MOORE SCHOOL OF ELECTRICAL ENGINEERING
UNIVERSITY OF PENNSYLVANIA

CYCLING UNIT TRANSFORMER PANEL

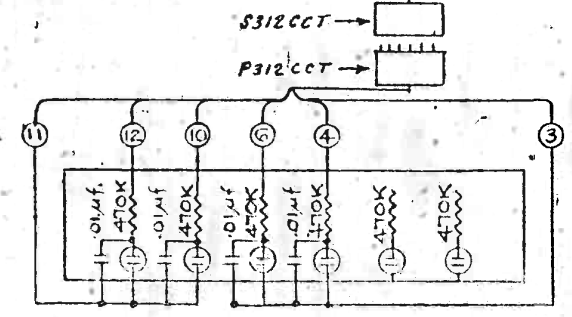
- REVISED
- 1 8-21-45
14-1 to H-5 INC. AND
H21-1 to H21-5. All H21-5
H21-1 to H21-5 100.
now H21-1 to H21-5 100
now H21-1 to H21-5 100
 - 2
H21-5 100
H21-5 100
 - 3
PHASE NAMES CHANGED.
SEMI-FINAL REVISION
11-14-45
 - 4
WIRING ON SOCKETS SM1 TO
SM6 & NEON LAMPS ALTERED
FOR 10000 V WYE OPERATION
 - 5
Summary 18 Jan 46
